STAFF SUMMARY REPORT (Vic Pal)
MEETING DATE: March 14, 2012

SUBJECT: **Turk Island Company, Turk Island Landfill, Union City, Alameda County** – Issuance of Updated Waste Discharge Requirements and Rescission of Order No. 97-026

Response to Comments - Item 5.C - Turk Island Landfill

FACILITIES PLAN
TURK ISLAND LANDFILL
 Union City, California
 Figure 3

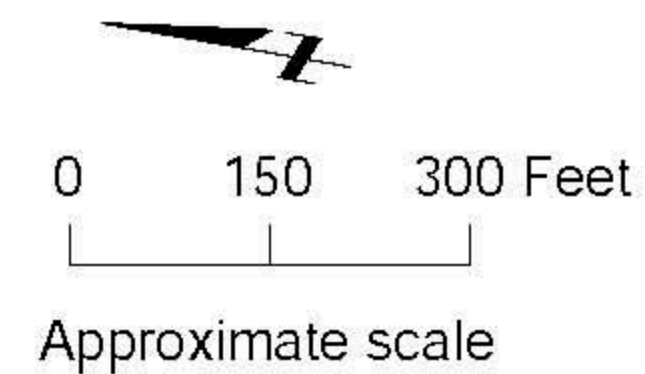
Comment 4 – *The monitoring program may have to be modified if ACWD decides to operate well 4S/2W-21B007 (Site D), which is located adjacent to the southwestern corner of the site. There are no current plans to operate Site D.*

Response 4: Table B-1 of the Self-Monitoring Program has been updated to reflect this contingency.
